### FREDERICK COUNTY HISTORIC PRESERVATION COMMISSION

## STAFF REPORT

**Case No.:** COA 24-02

**Request:** Remove temporary roofing and associated substructure from second floor that was part of COA #22-09; install new porch subfloor and Duradek vinyl flooring; install simple, white wooden railings with square balusters around the new second story porch; install a storm door on the exterior second floor door that leads to the new second story porch.

*Image 4: Diagram of Duradek's Construction*

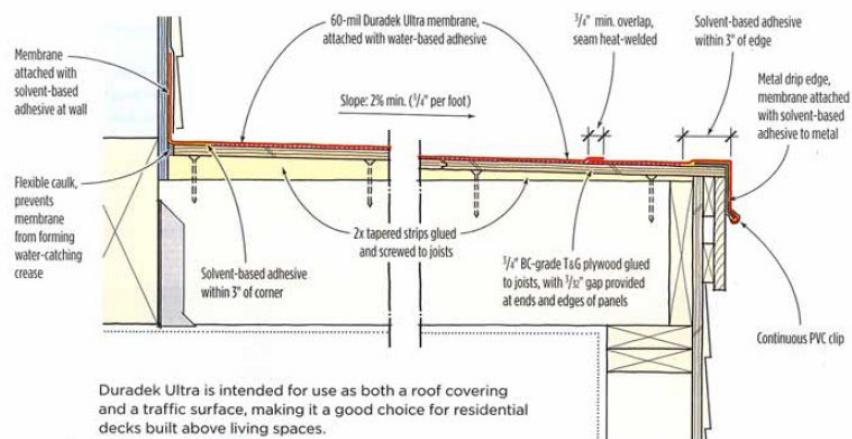
The applicant is proposing to use Duradek vinyl material as the flooring material for the proposed porch. This is designed to keep the rooftop porch waterproof. The applicant has included a product brochure and color guide for the Commissioners to review. At this time, a material color has not been chosen but Staff suggests Classic Steel. Commissioners are welcome to provide their own view on the color options provided by the applicant.

Staff is suggesting that the Classic Steel color be used because the vinyl material matches sheet metal in thickness, massing, scaling, and rhythm better than a wooden texture. This historic house also has gray standing seam metal roofs, so the color reflects that while being a noticeable difference, as to not create a false sense of history, and create a usable, waterproof porch.
